Accessibility Survey

City of Downey Orange Street - Birchdale Avenue To Brookshire Avenue

Date of Inspection
2/5/2017

Disability Access Consultants

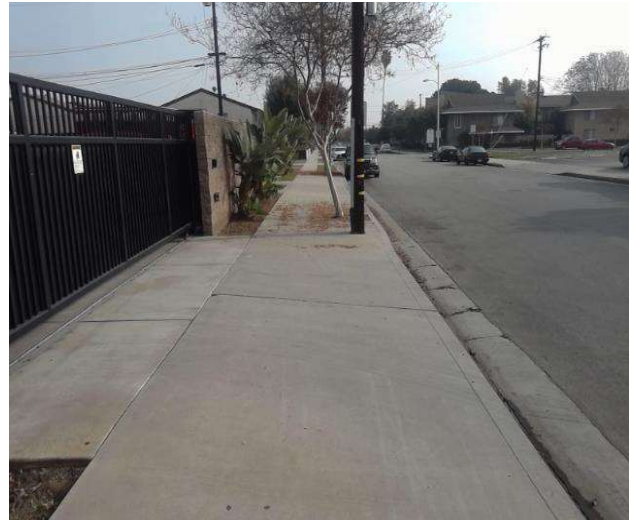
There are no detectable warnings where the pedestrian route crosses vehicular traffic.

On-Site Finding Not Found

Provide detectable warnings.
